22nd Nov 2007: Update #1. CSQ1 & CSQ2 overlay was incorrect.
Value should be 1nF

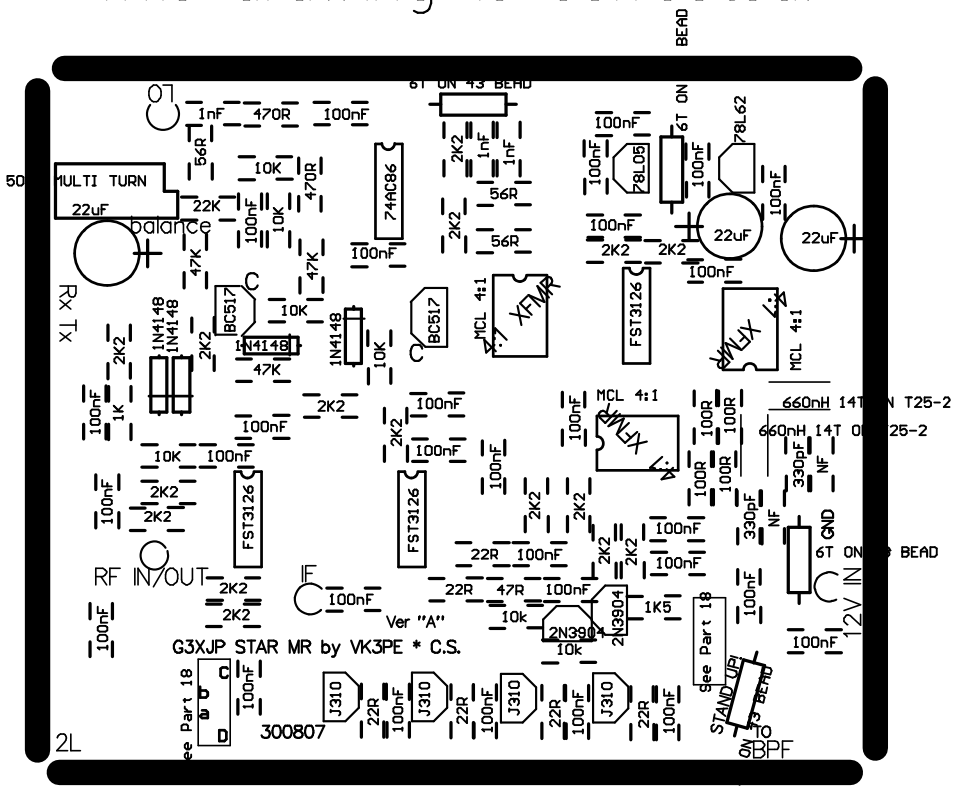
Update 2 changed U310 to J310's

This drawing is corrected.
